Addendum #	02	Date Issued	03/31/2025
Project Name Job #	SWN 0509, Waneta Hall Renovate Restrooms	OSE # R0325--15X	EAPC #20256780
Bid Date Time	April 3, 2025		3:30pm

THIS ADDENDUM AMENDS AND BECOMES PART OF THE CONTRACT DOCUMENTS FOR EAPC PROJECT 20246780 DATED 03/13/2025, RESPECTIVELY. EACH BIDDER SHALL ACKNOWLEDGE RECEIPT OF THIS ADDENDUM BY MARKING THE ADDENDUM NUMBER AND DATE ON THE BID FORM.

DRAWING TITLE
FINISH PLANS - ADD ALTERNATES

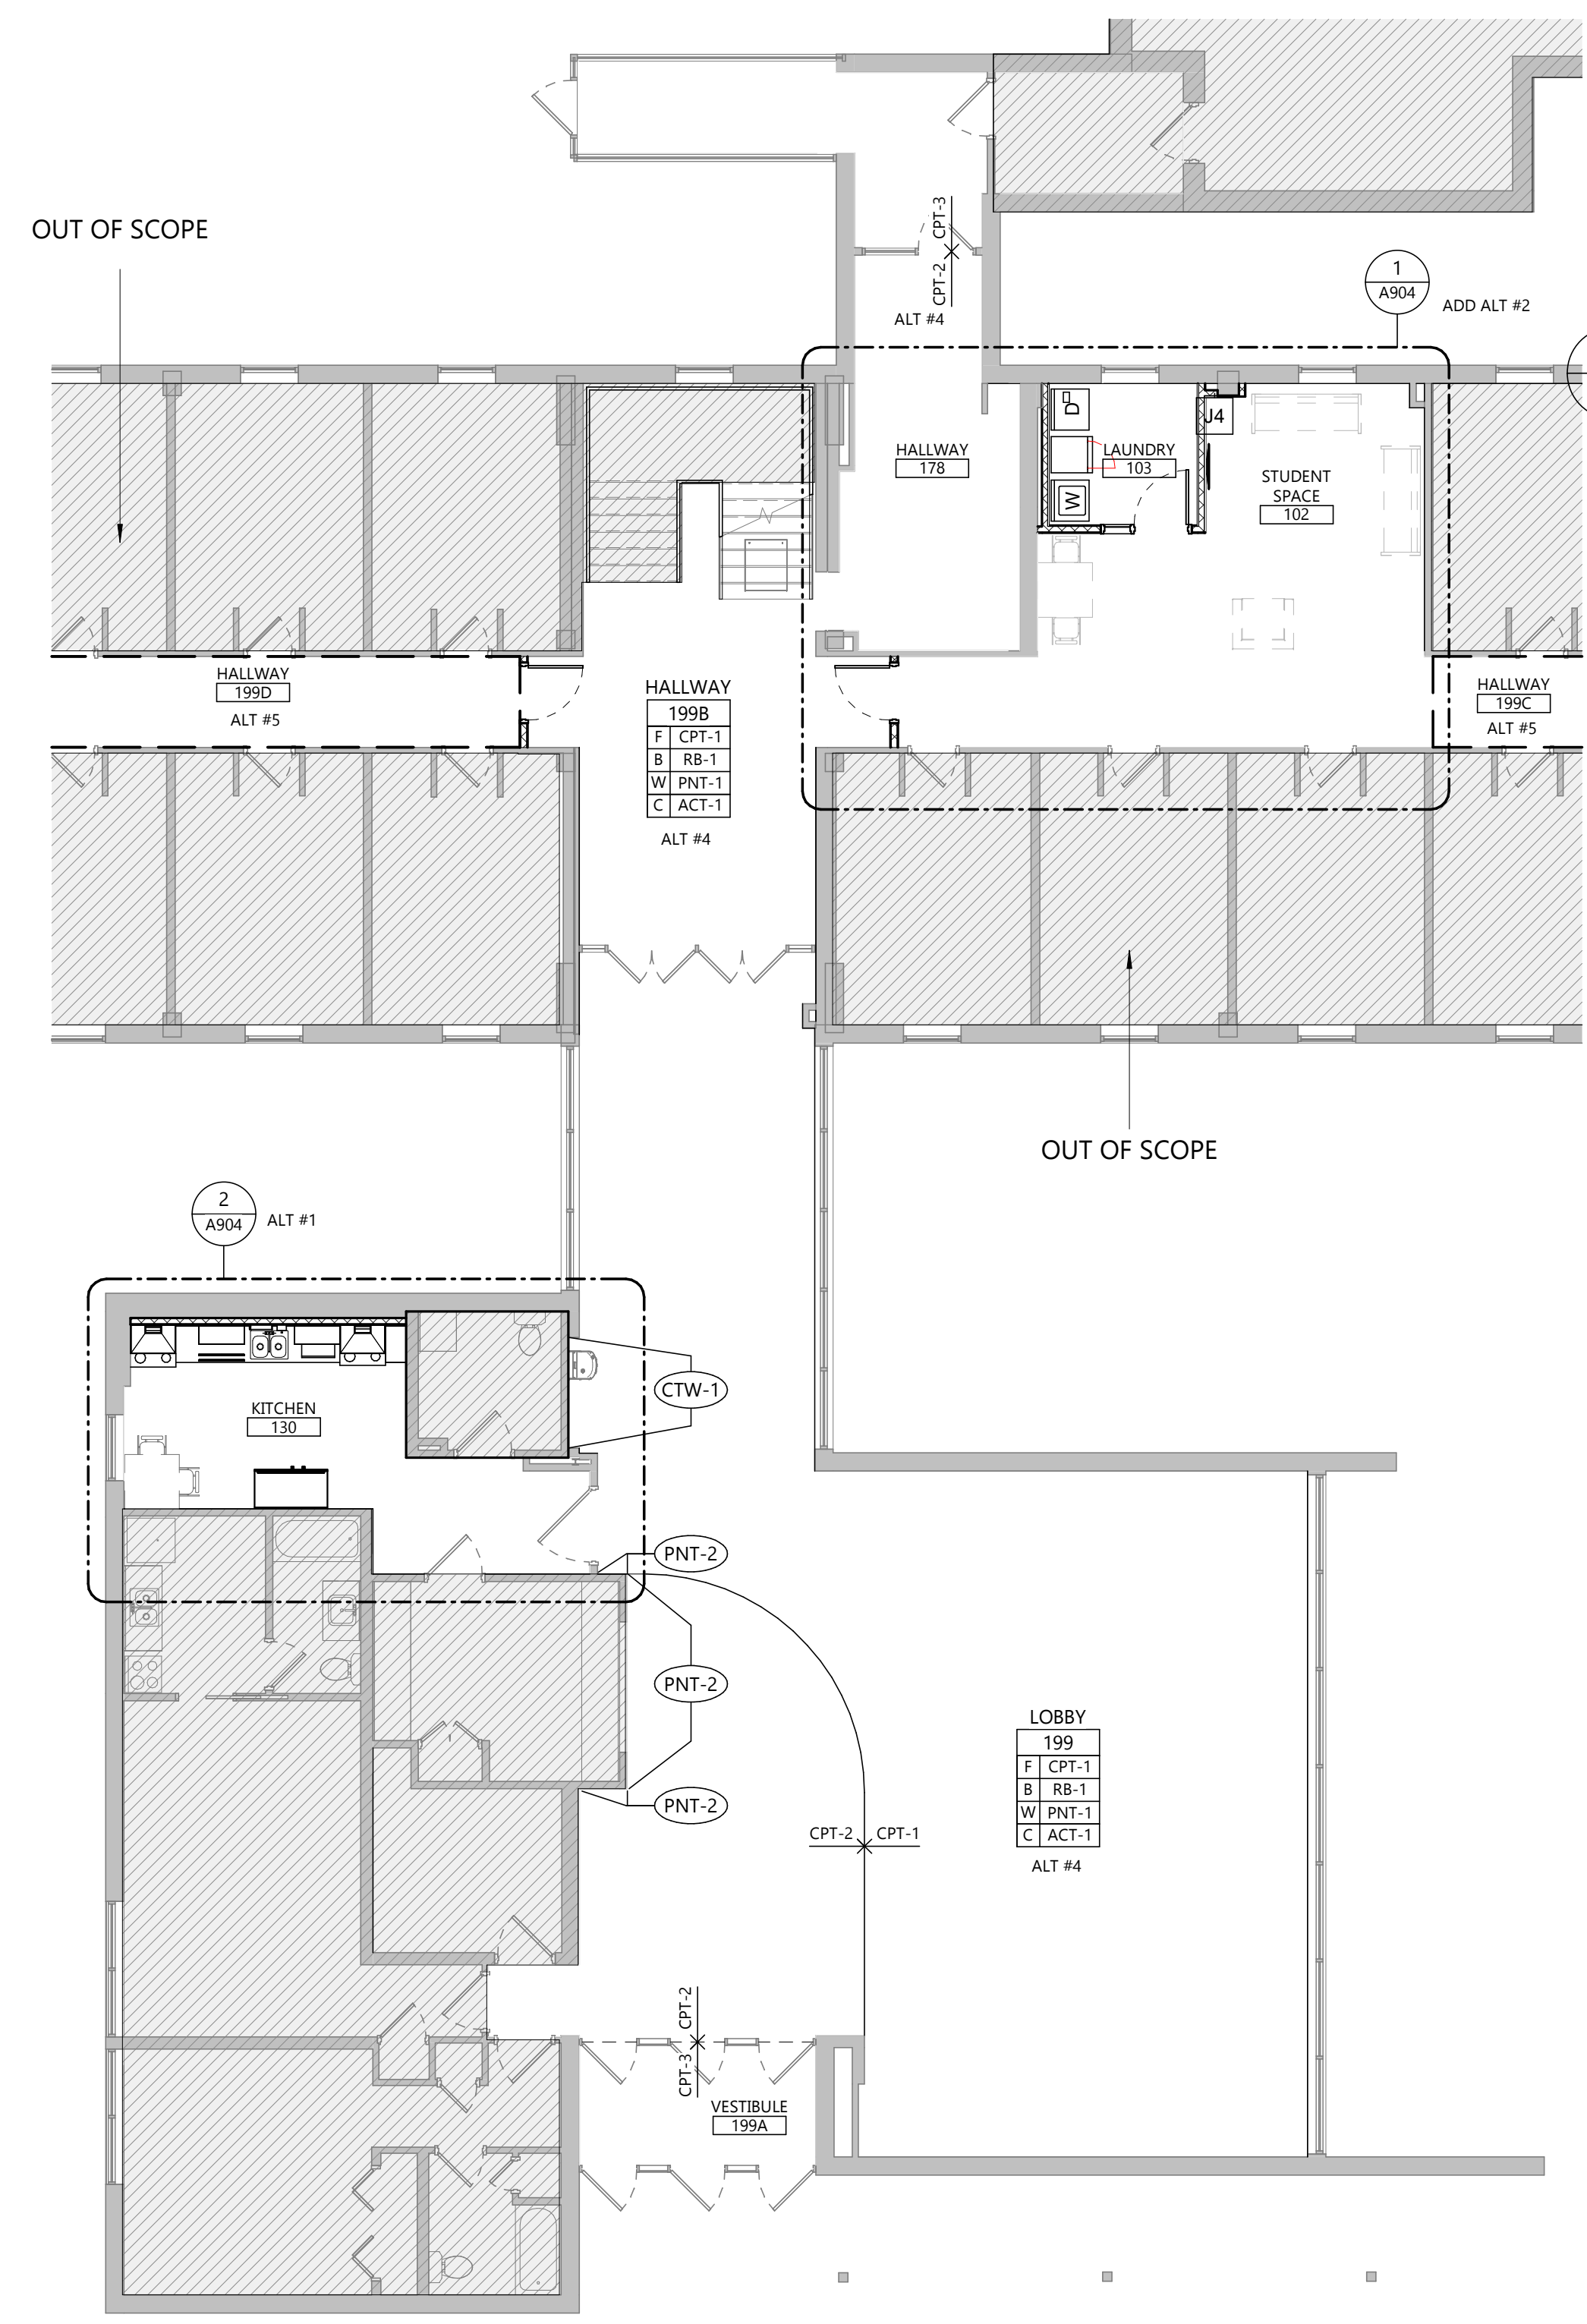
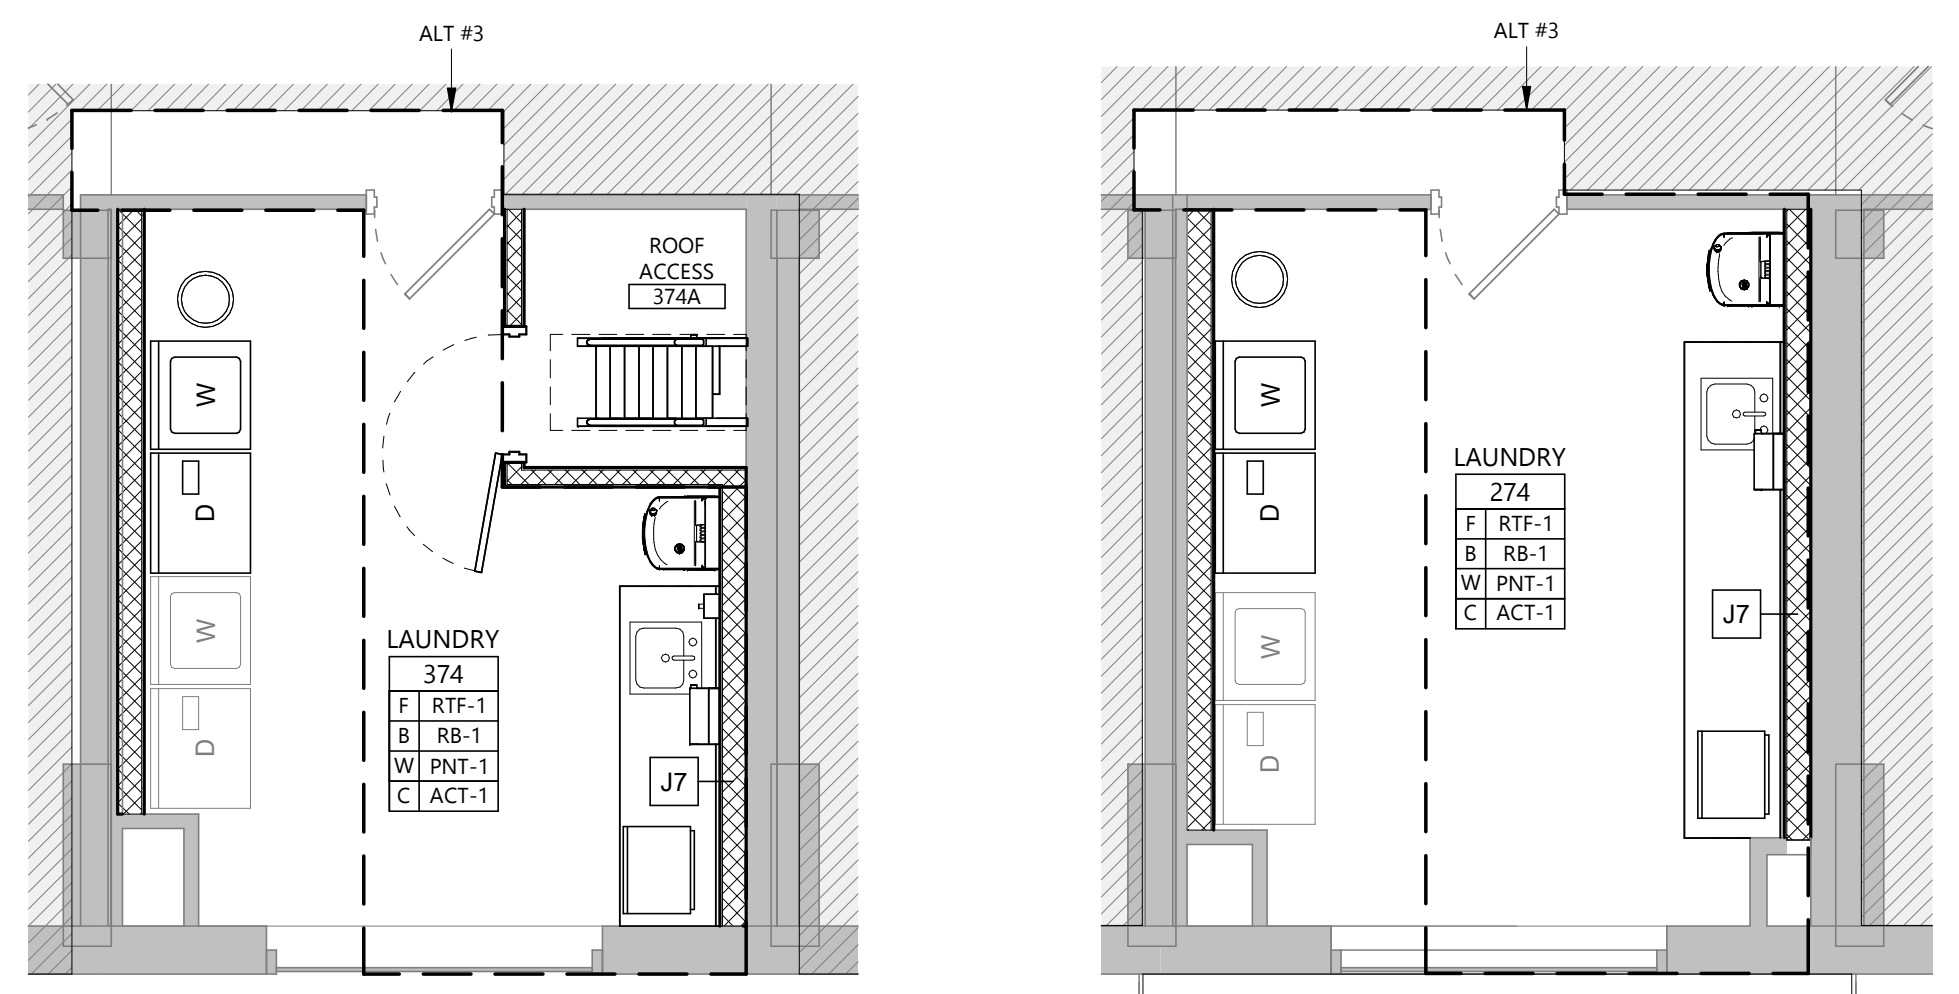
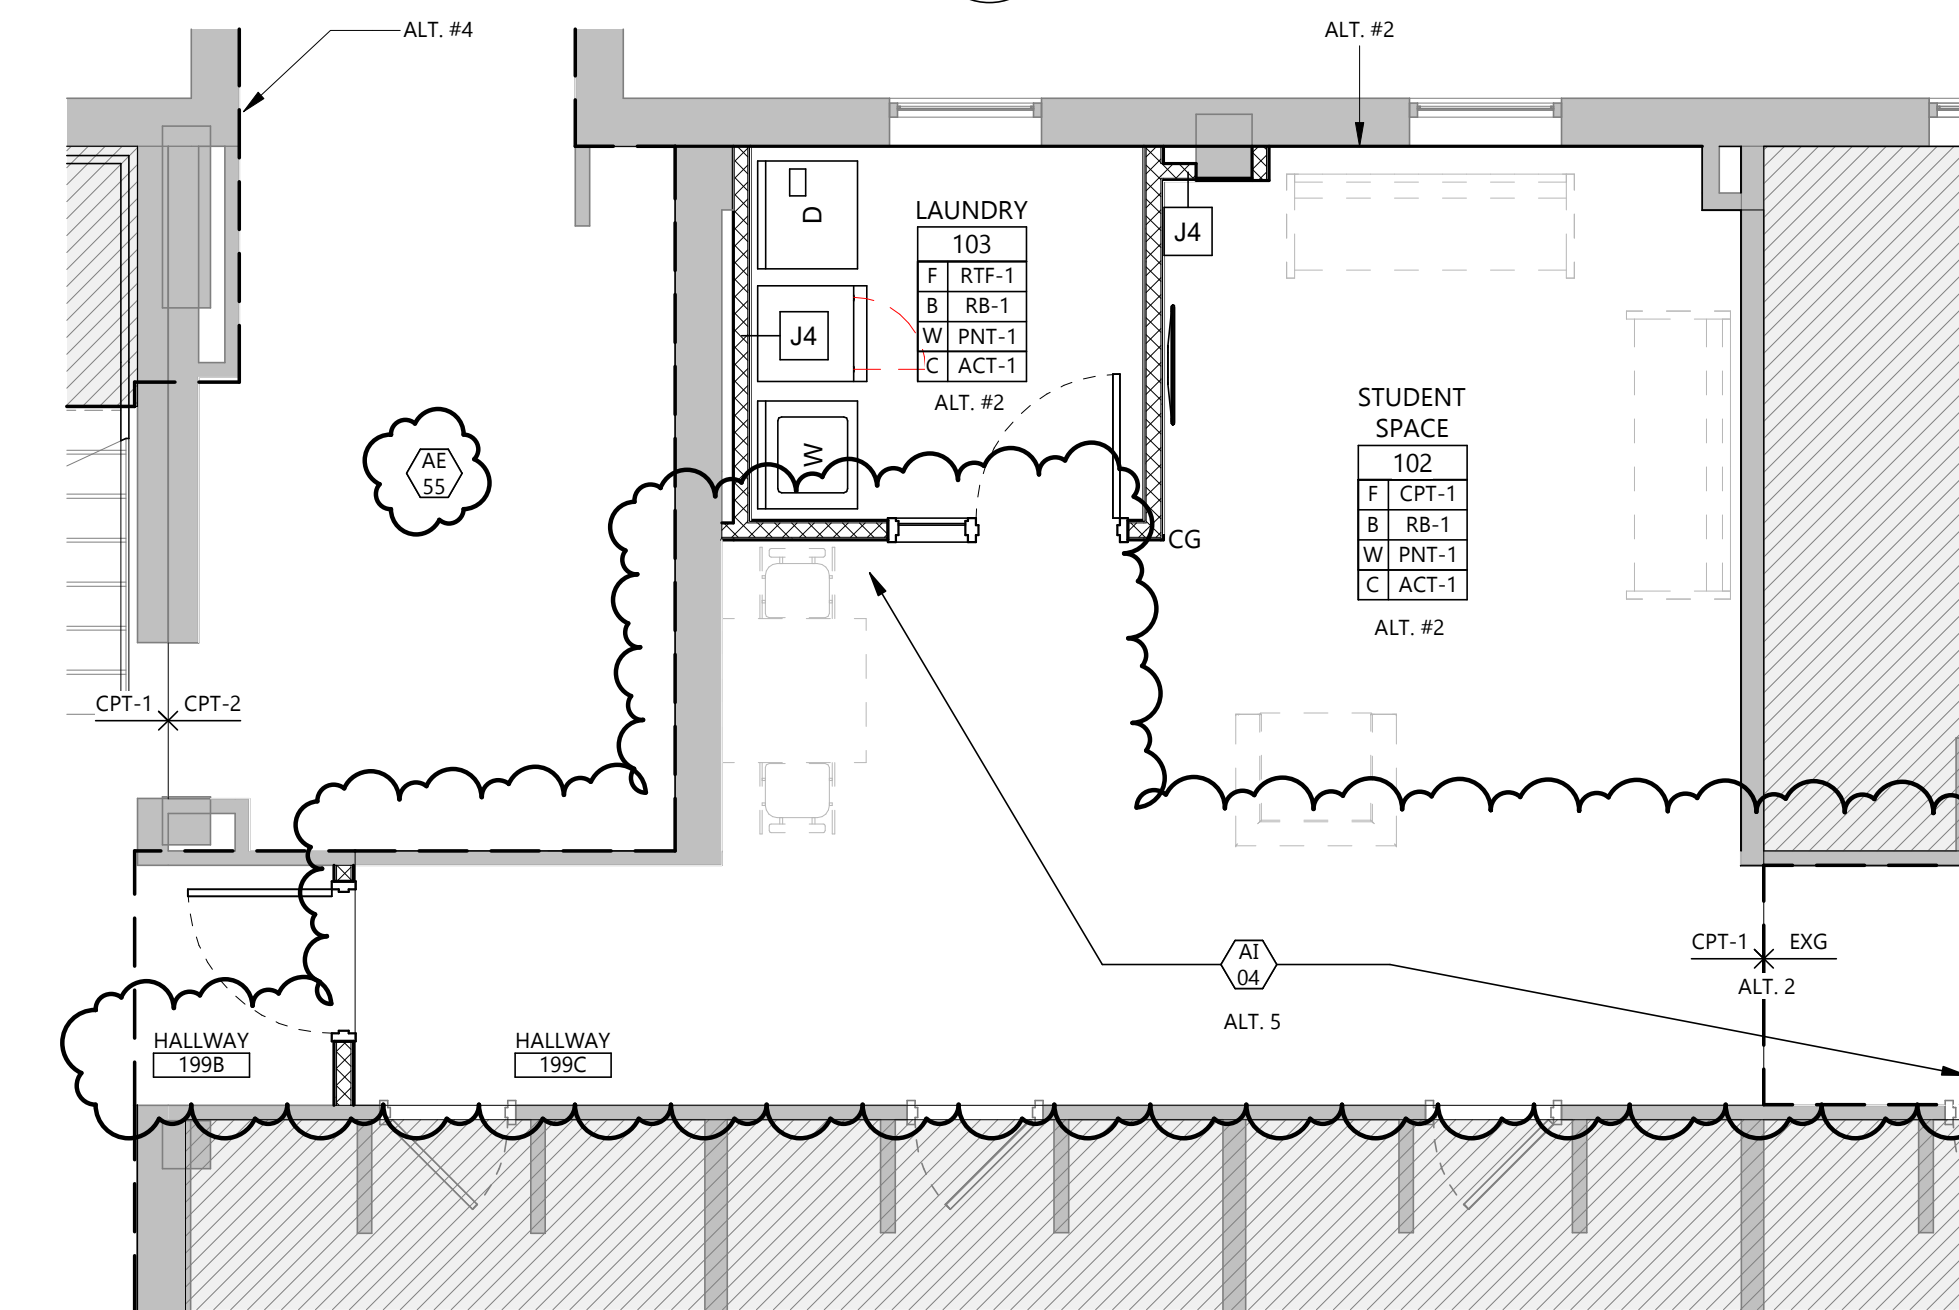
- A902 REVERSE Keynote AI 03.
CLARIFY paint finishes at General Finish Notes 5,17,19, and 22.
- A904 REVERSE Keynote AE 02 to AE 55.
ADD Keynote AE 55 and REVERSE AI 04 in Keynote Legend.
REVERSE finish transitions and CLARIFY room numbers at detail 1/A904.
CLARIFY paint finishes at General Finish Notes 5,17,19, and 22.
